Rezoning Application:
MM 22-1392
 Zoning Hearing Master Date:
04/17/2023
 BOCC Land Use Meeting Date: **06/13/2023**

The applicant is seeking a major modification to the existing Planned Development (PD) 06-0103, as modified by MM 21-1108. This modification to the PD includes one 7.2-acre parcel. The proposed development substitutes 38 single-family duplexes for 38 single-family dwellings consisting of a combination of duplex, three-unit (triplex) and four-unit (quadplex) buildings. The applicant proposes a change in the form, but not the unit count already approved.

2.4 Existing Site Plan (partial provided below for size and orientation purposes. See Section 8.0 for full site plan)

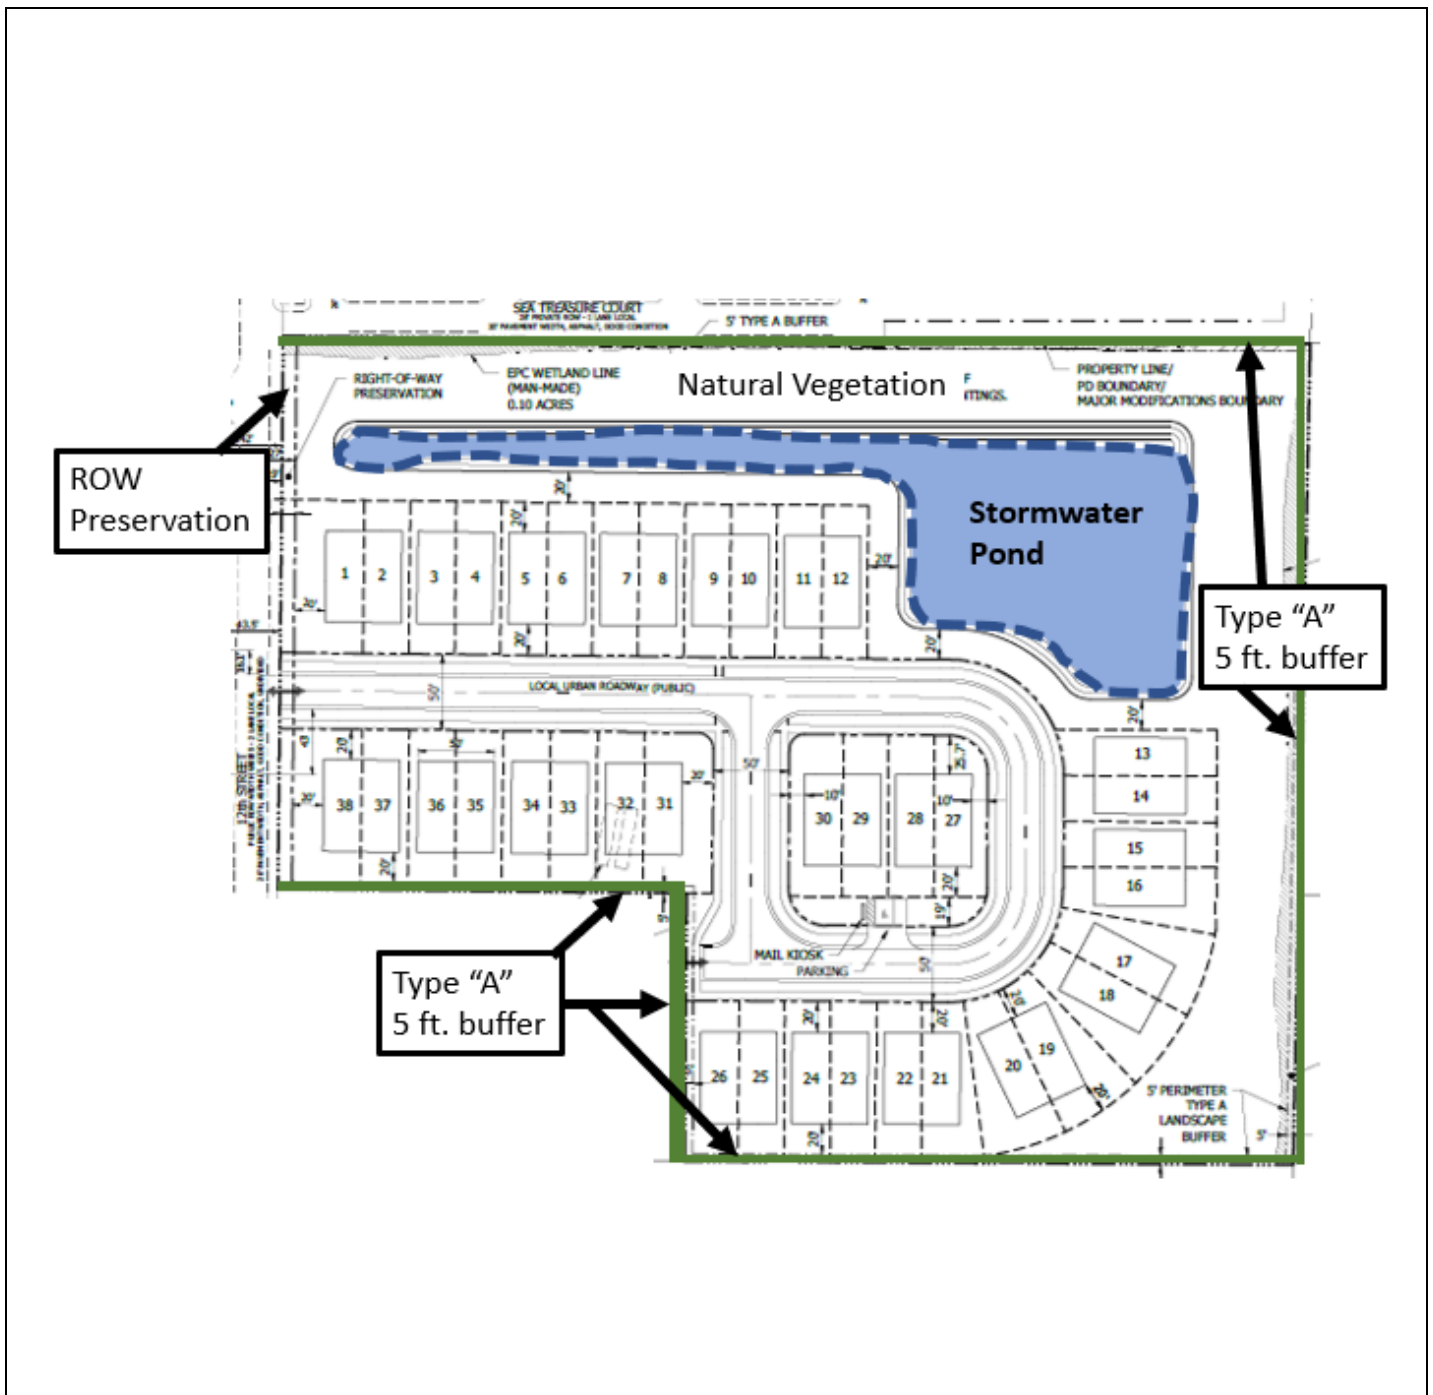
MM 21-1108 was approved for 38 villa/duplex units on 30' x 100' lots, with a minimum lot area: 3,000 sf, minimum lot width: 30', 20' front yard except for corner lots, 20' rear yards, 5' side yard, and a maximum height of 35'. The development also provided a 5 ft. buffer / Type "A" landscaping adjacent to the property east and southern property boundaries. While not required, the applicant provided a 5 ft. buffer / Type "A" landscaping on the north side of the PD boundary.

2.5 Proposed Site Plan (partial provided below for size and orientation purposes. See Section 8.0 for full site plan)

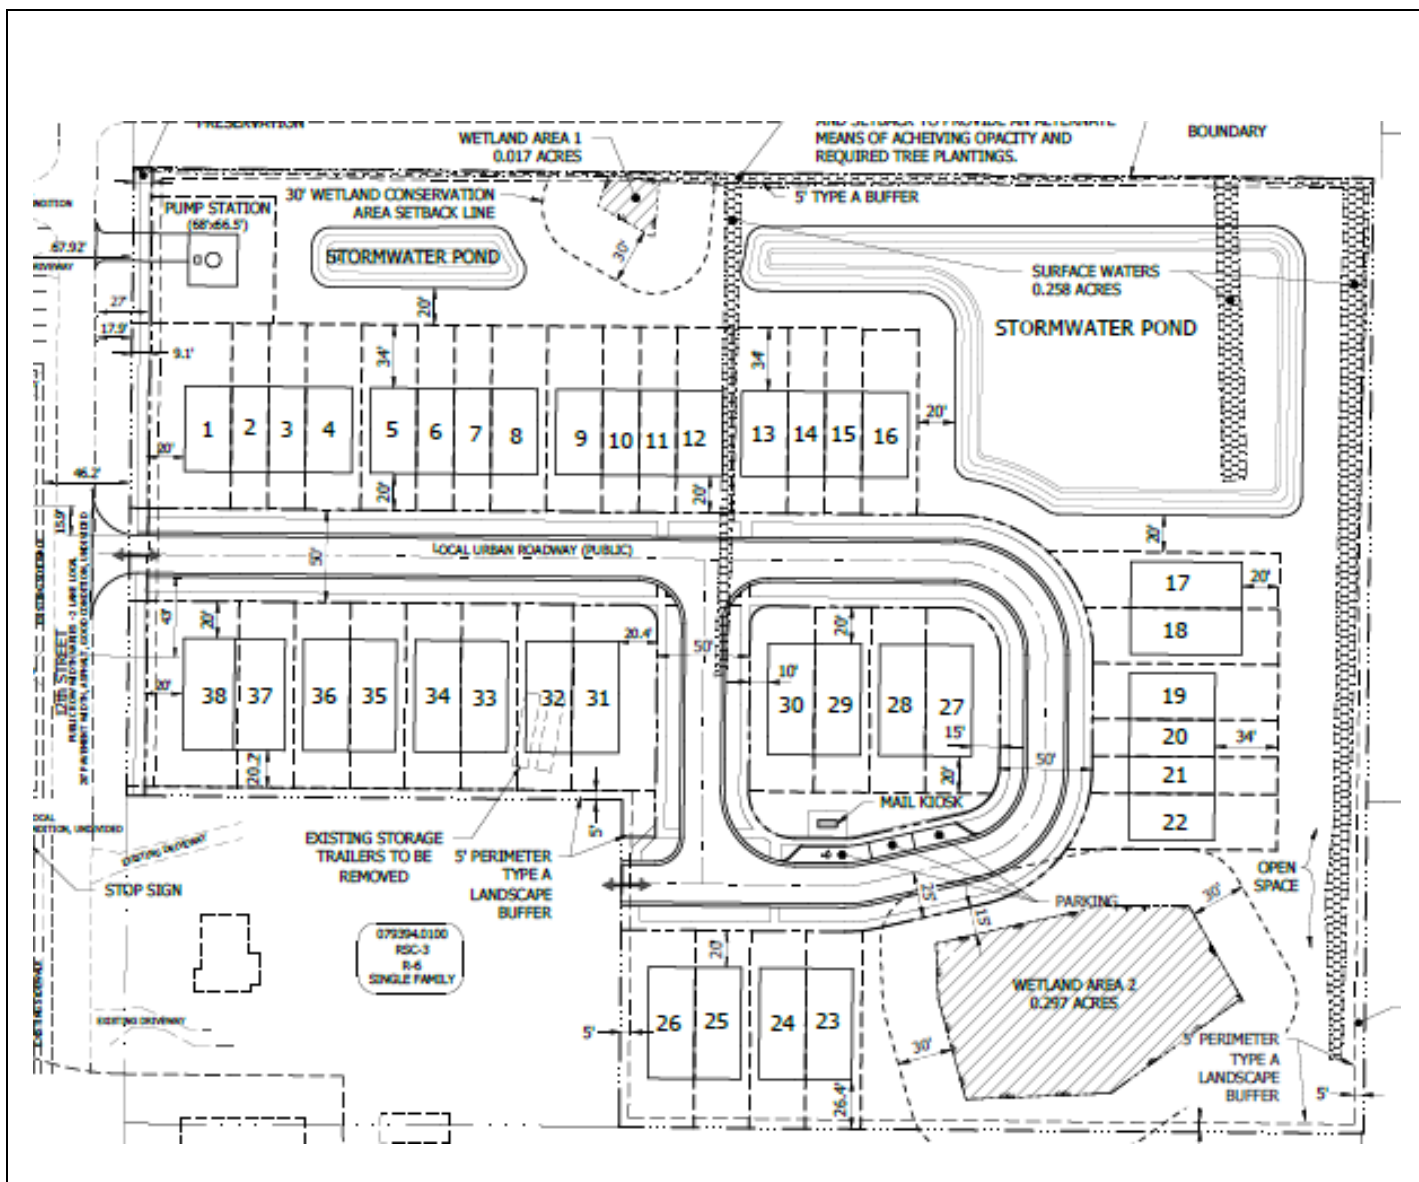
The applicant is proposing 38 units comprising duplexes, triplexes and quadplexes. The following dimensional standards are proposed by the applicant:

- 2,000 square feet to 4,500 sf maximum lot area
- Front yard: 20-foot setback

The applicant proposes to provide a 5 ft. buffer / Type "A" landscaping adjacent to the property east and southern property boundaries. While not required, the applicant also proposes to provide a 5 ft. buffer / Type "A" landscaping on the north side of the PD boundary.

Figure 1 - Improvement Network

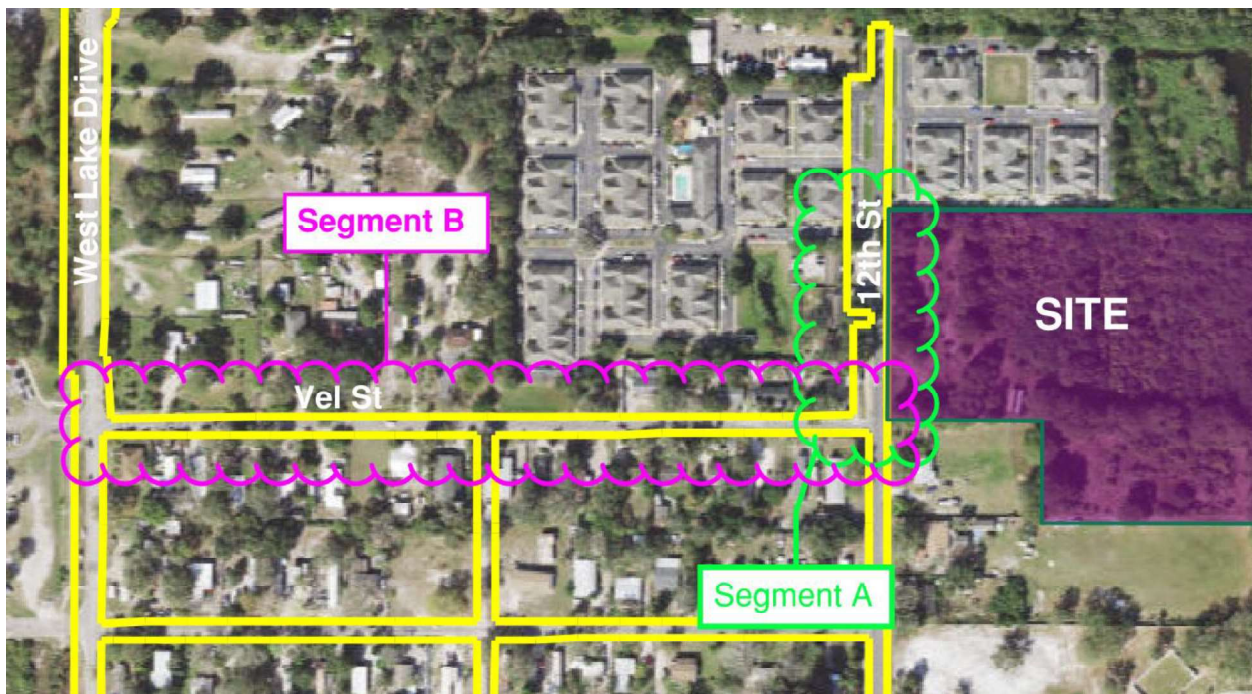
The nearest County roadway complying with Essential Elements to the project site is West Lake Drive. For this analysis, we have considered the frontage of the property along 12th St as Segment "A", and Vel Street from 12th St to West Lake Drive to be Segment "B".
